HAULMAAX[®] Tie-bar Bolster Spring

SUBJECT: Kit No. 64179-037

LIT NO: 59310-029

TIE-BAR BOLSTER SPRINGS

FIGURE 1

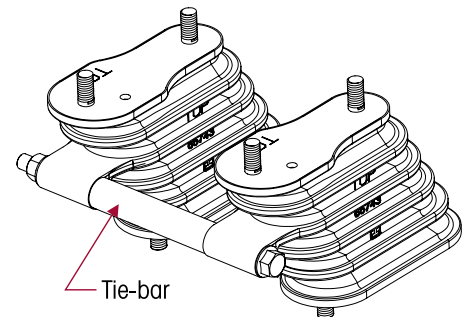
Effective in June of 2006, a new enhanced bolster spring package will be phased into production for the HAULMAAX[®] 46K suspension system. The new design features a tie-bar, which connects the bolster springs using a bolt, spacer, and nut. This newly enhanced bolster spring package is intended for all HAULMAAX 46K applications.

Effective in June of 2006, Hendrickson will only offer a new tie-bar bolster spring (Kit No. 64179-037) for HAULMAAX 46K suspension service purposes. Installation of the tie-bar bolster spring (as detailed in the disassembly and assembly instructions in this publication) is similar to the existing bolster springs, with the addition of the tie-bar spacer, bolt and locknut, see Figure 1.
